SUBJECT: KINGSTON STEAM PLANT - ANNUAL JOINT INSPECTION OF THE ASH DISPOSAL AREAS
POWER ENGINEERING AND FOSSIL AND HYDRO POWER

TITLE KINGSTON STEAM PLANT - ALL UNITS - ANNUAL JOINT INSPECTION BY THE DIVISION OF POWER ENGINEERING AND CONSTRUCTION AND THE DIVISION OF FOSSIL AND HYDRO POWER		REPORT NO. FEP-ASH-86-6		PLANT/UNIT KINGSTON STEAM	
		SAR SECTIONS			
		VENDOR		CONTRACT NO.	KEY NOUNS
		REV	(FOR RIMS USE)	RIMS ACCESSION NUMBER	
		R0		B65 '86 0520 009	
APPLICABLE DESIGN DOCUMENTS		R1			
		R2			
REFERENCES		R3			
		R4

SUBJECT: KINGSTON STEAM PLANT - ANNUAL ASH DISPOSAL AREA INSPECTION

① *REDWATER SEEPAGE AT
INTAKE CHANNEL.*

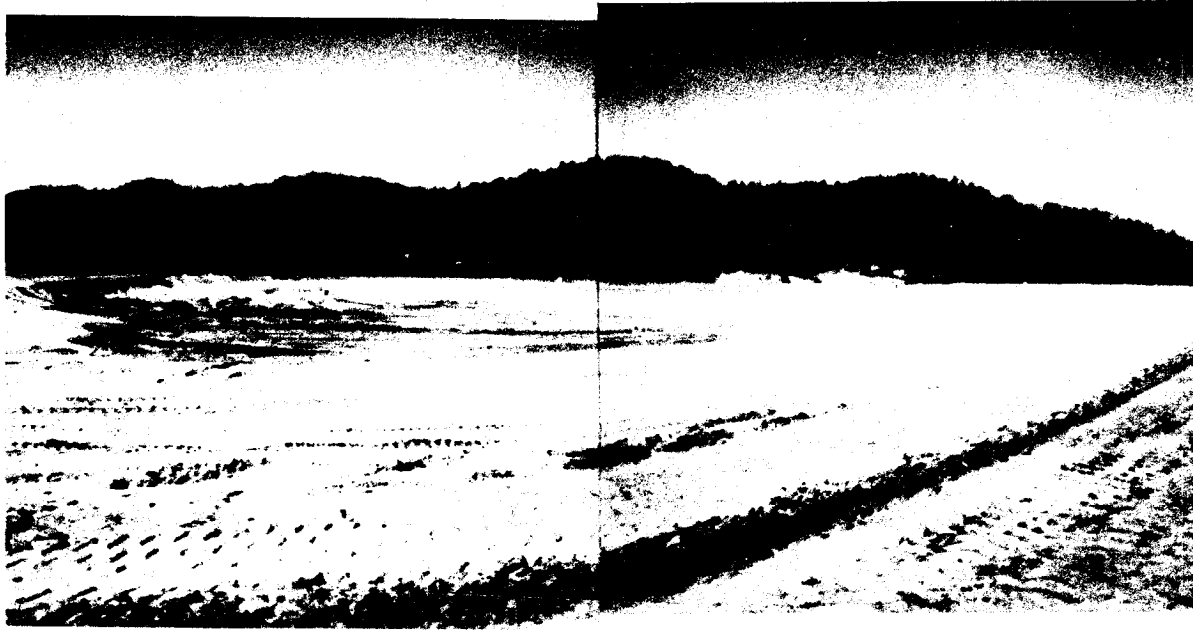
2.2 The acidic drainage is still evident along the slopes of the southeast dike. While the seepage at the east end has subsided (picture No. 1), due to the interceptor ditch formed at the base of the ash stack (picture No. 2), the seepage at the east end of the south dike was quite evident (picture No. 3).

4 DREDGE POND NORTH AREA.

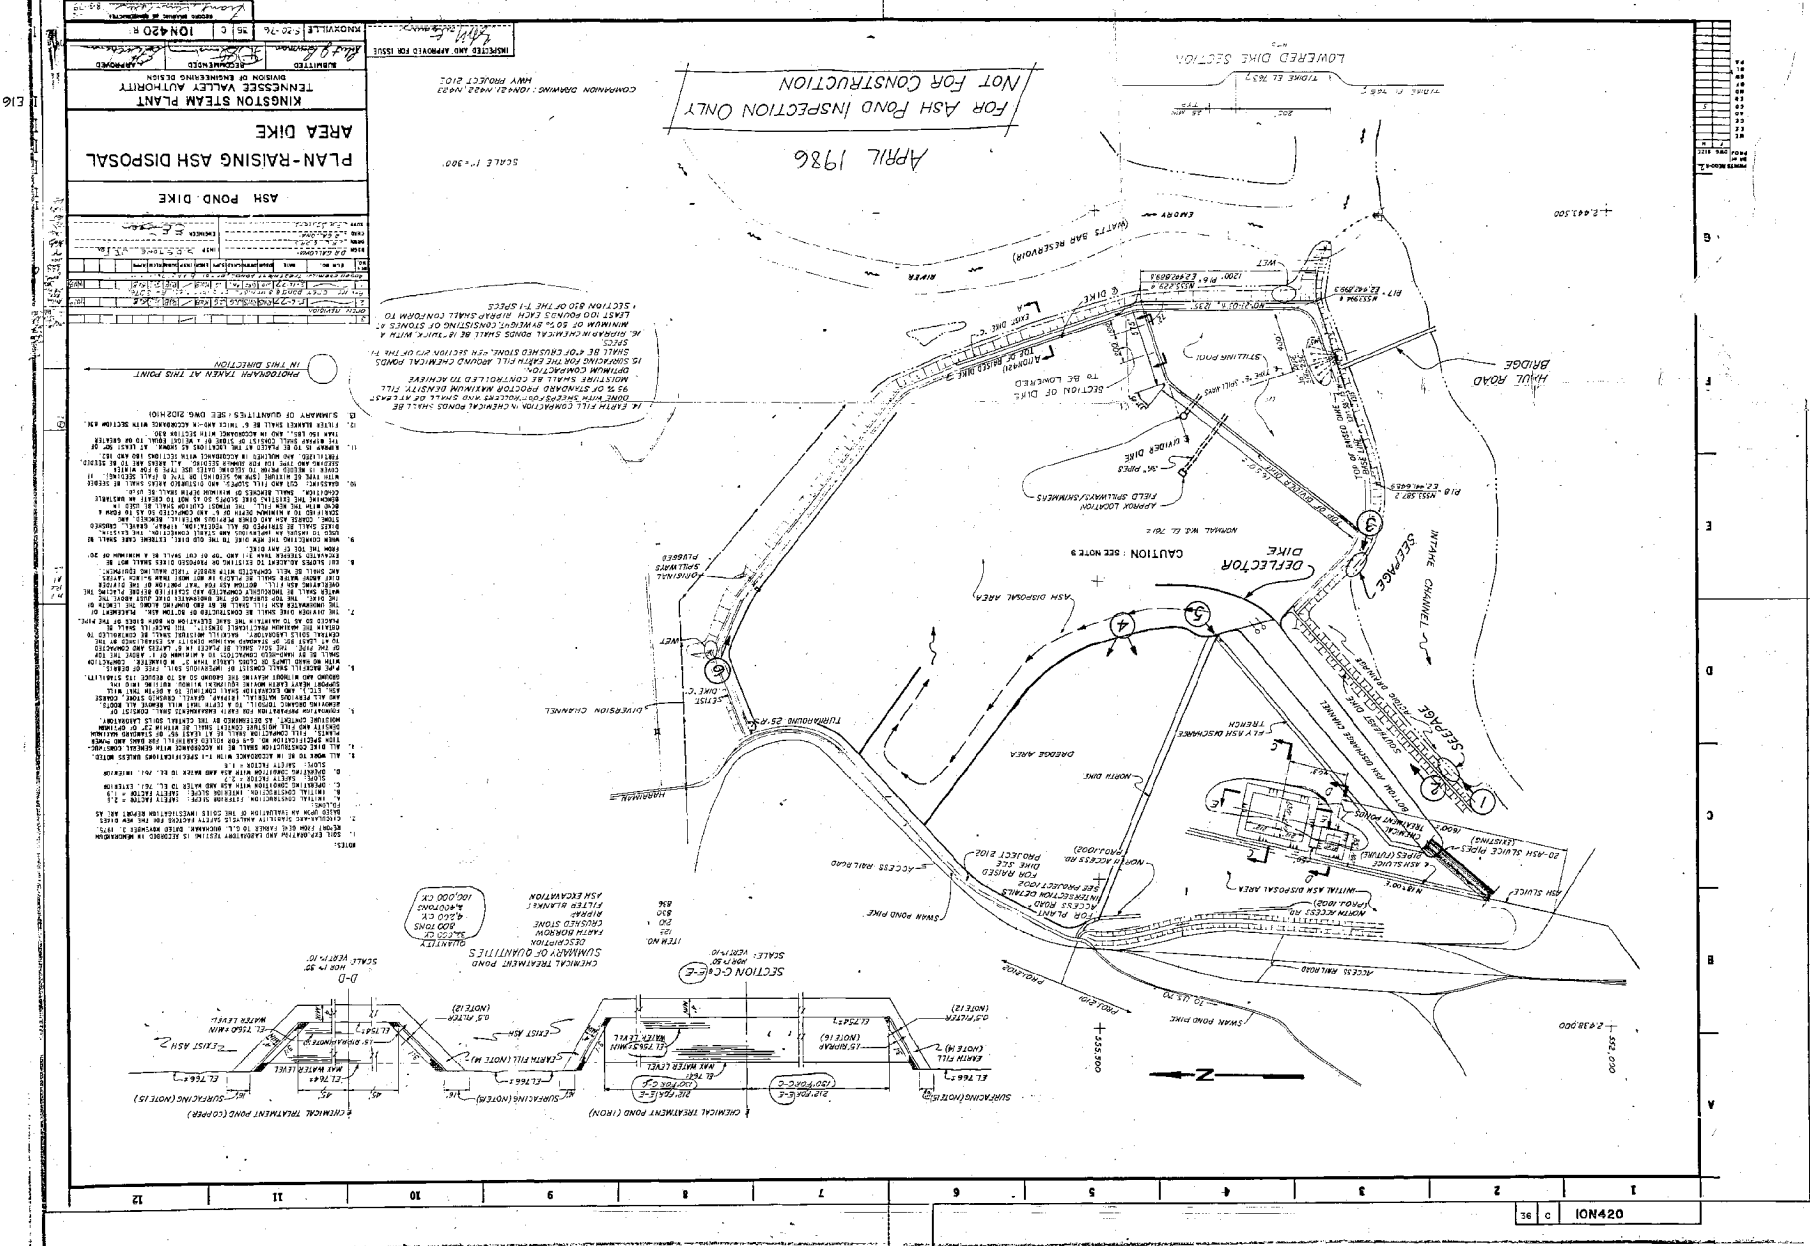
3.1 The internal dredge pond dikes are being raised several feet in preparation for future storage by dredging (picture No. 4) (see 6.2).

- 6.1 The lower exterior berm should be mowed to enhance a more effective visual inspection. All undesirable vegetation should be removed by use of chain or cable so as to pull the root system from the earth.
- 6.2 While the raising of internal dikes may be essential for the storage of ash due to ever decreasing available space, these dikes should be analyzed for structural stability.
- 6.3 Final grading should insure a proper ditch gradient such that no standing water is permitted.
